Shop Drawing Submittal Review

Project Name: Webster University-**ISB**

Copies	No.	Description
1 PDF	224216P02	(Submittal No.'s)
		(Cannon #22 4216.16-001) - (Paric #15051-) – (WES #607)
		➢ **Commercial Sinks**
		• Clinical Service Sink CSS-1
		• Scrub Sink SS-1
		• Sink SK-1
		• Garbage Disposer GD-1
		• Sink SK-2
		• Sink SK-3
		• Mop Sink MS-1
		• Kitchen Sinks KS-1, KS-2, KS-3

PROJECT NAME:	Webster University ISB
LOCATION:	St. Louis Missouri
CLIENT PROJ. NO.:	N/A
WES PROJ. NO.:	607
SPEC SECTION:	22 4216.16 Commercial Sinks
SUBMITTAL ITEM:	See Below -

SCR1B/ SCR09/ SCR19/ SCR39/ SCR49 Multi-Turn Angle Stop w/ Loose Key – Compression x Compression

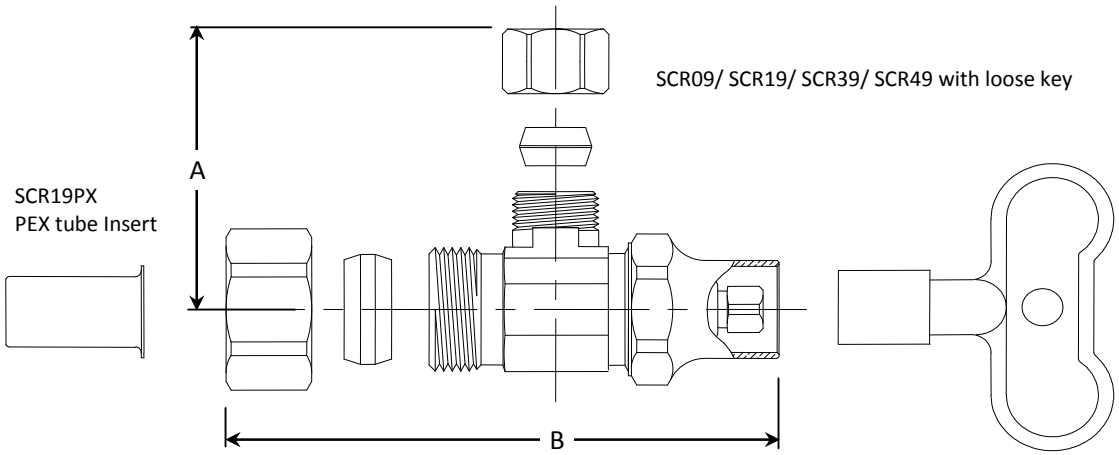
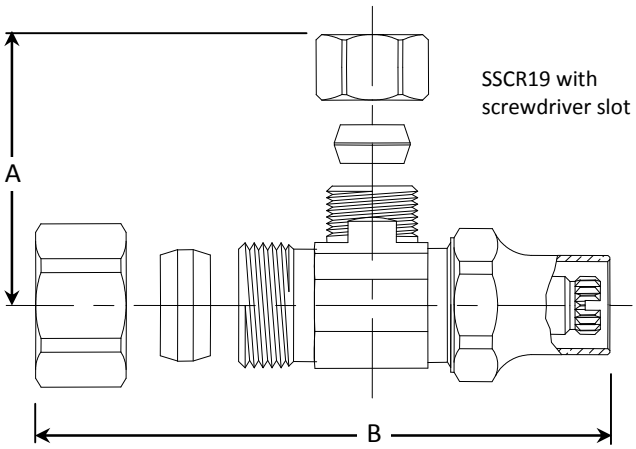
X					P-Trap Proflo Model PFPTB403	
X					Angle Stops BrassCraft Model SCR19XC	
X					Supply risers BrassCraft Model 1-12A C	
	X				Escutcheons Proflo Model PFE7	Escutcheons are specified to be cast brass. Refer to specification section 220518.
Sink SK-1						
X					Fixture Elkay Model GECR2521	
X					Faucet Chicago Faucet Model 200-AABCP	
X					Outlet Waste Disposer Kit Proflo Model PFEWB200	Provide under counter waste and supply protective piping covers as required. Verify requirements with the architectural drawings.
X					P-Trap Proflo Model PFPTB403	
X					Angle Stops BrassCraft Model SCR19XC	
X					Supply Risers BrassCraft Model 1-12AC	
	X				Escutcheons Proflo Model PFE7	Escutcheons are specified to be cast brass. Refer to specification section 220518.
Garbage Disposer GD-1						
X					Fixture Emmerson In-Sink-Erator Model Evolution Compact	
Sink SK-2						
X					Fixture Elkay Model LRAD1517	
X					Faucet Chicago Faucet Model 895-317GN2AE29ABCP
